**Request for Additional Information No. 512 (6048), Revision 0,
Question 07.08-50**

U. S. EPR Standard Design Certification

SRP Section: 07.08 - Diverse Instrumentation and Control Systems

Application Section: ANP-10304 Revision 4

Figure 4-1—Block Diagram for D3 Assessment

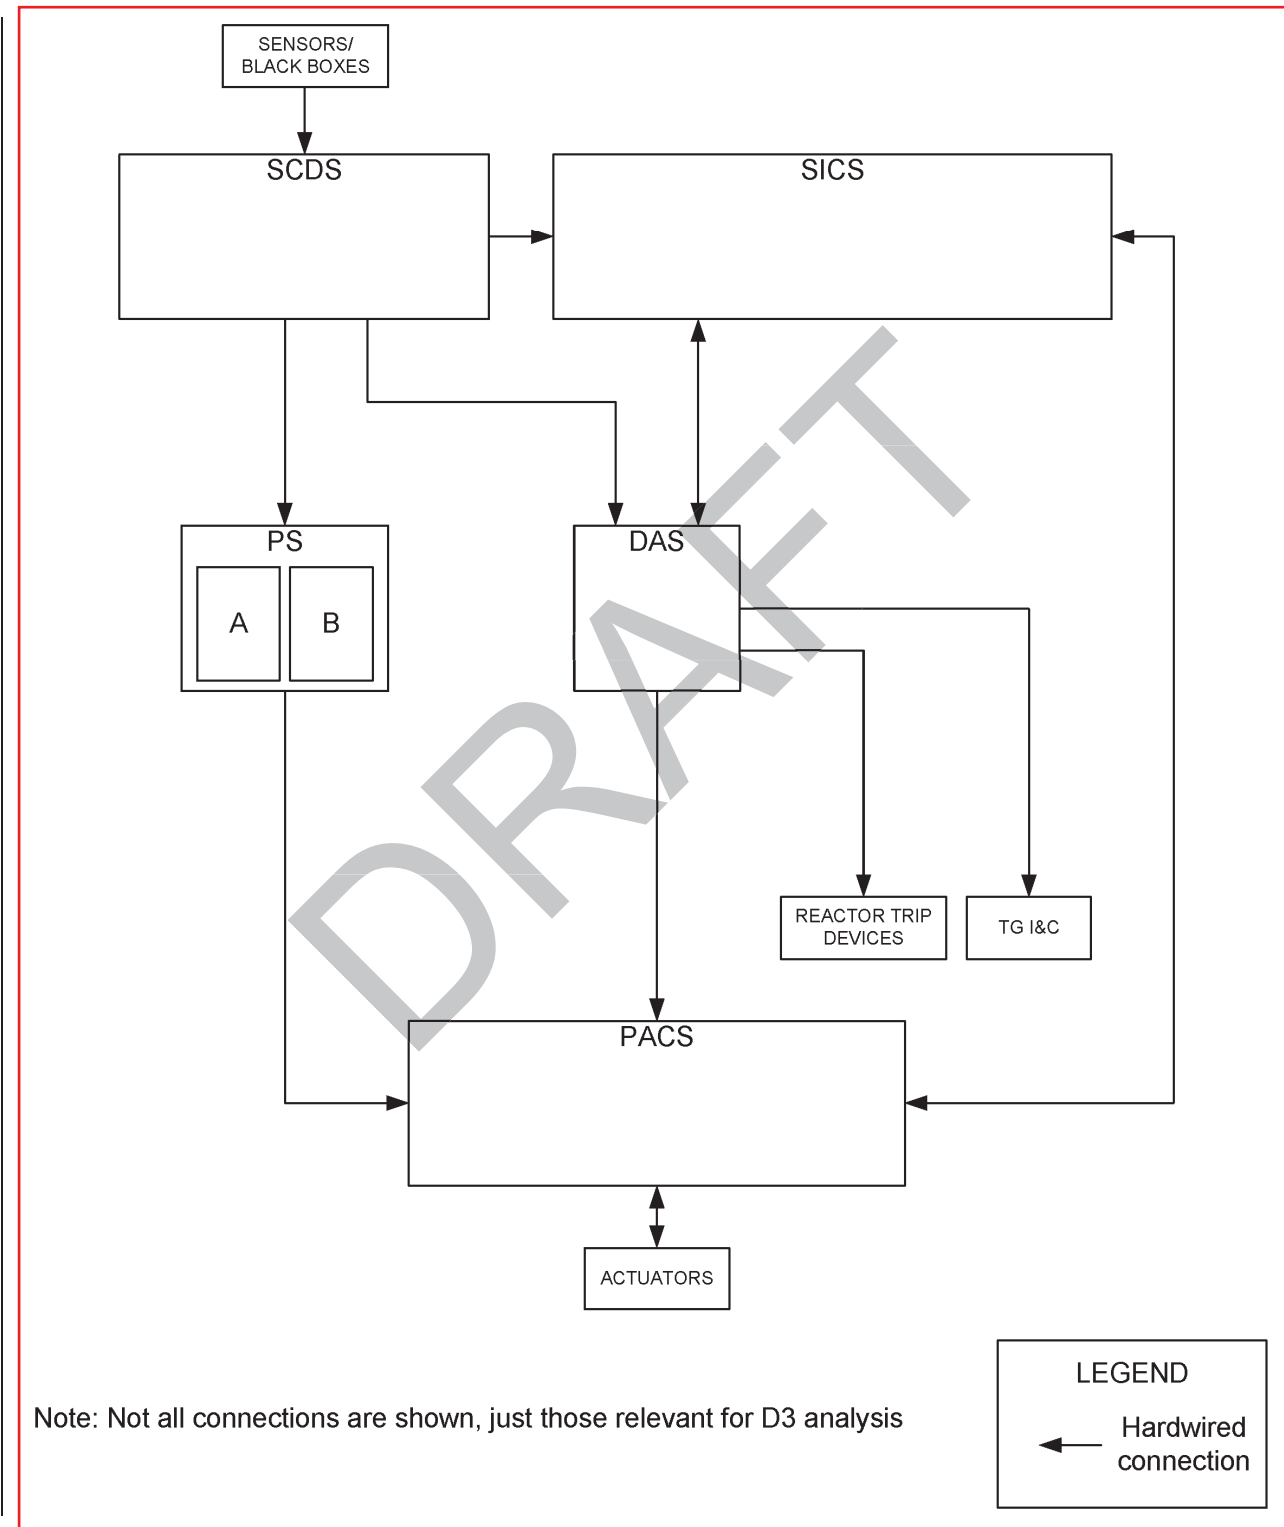
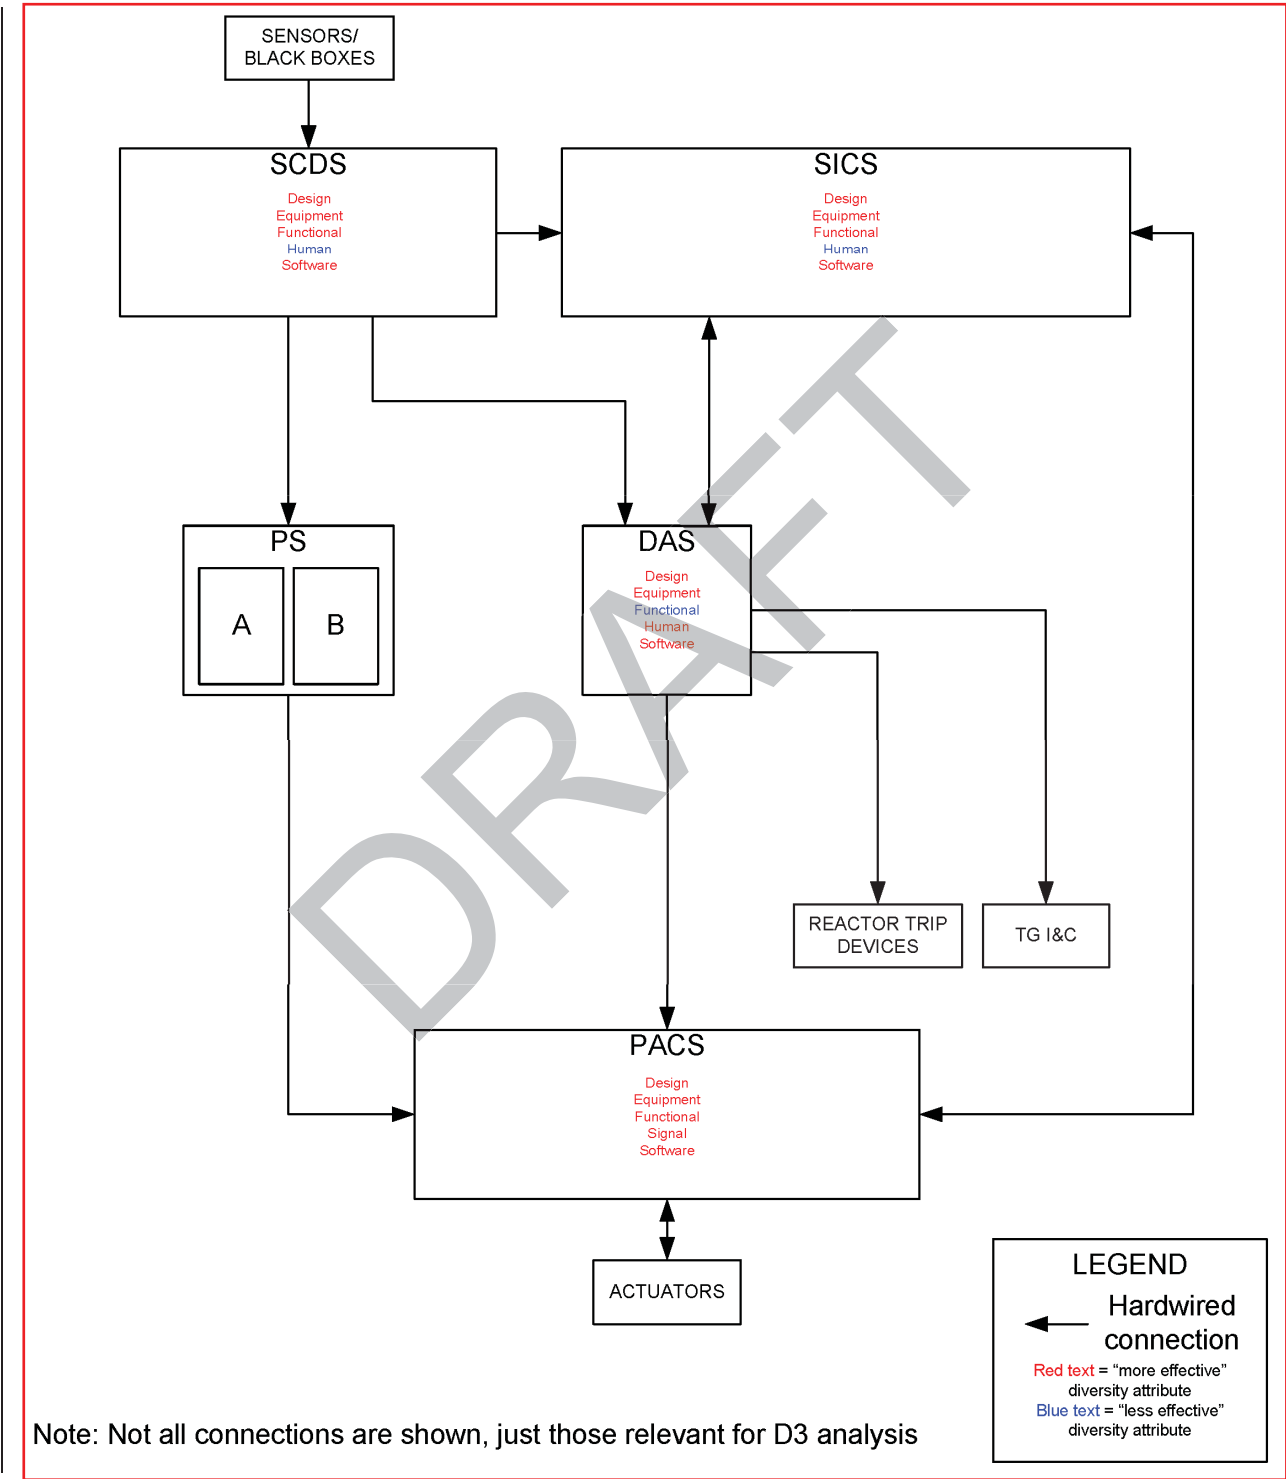
<u>Pages 4-5 and 4-6</u>	<u>Added clarification for SICS design and software diversity</u>
	<u>Pages 4-10 and 4-11</u>	<u>Added clarification for DAS human and software diversity</u>
	<u>Figures 4-1 and 4-2</u>	<u>Replaced</u>
	<u>Appendix A</u>	<u>Revised to reflect treatment of SWCCF in SAS and to clarify results for Increase in Steam Flow Event</u>
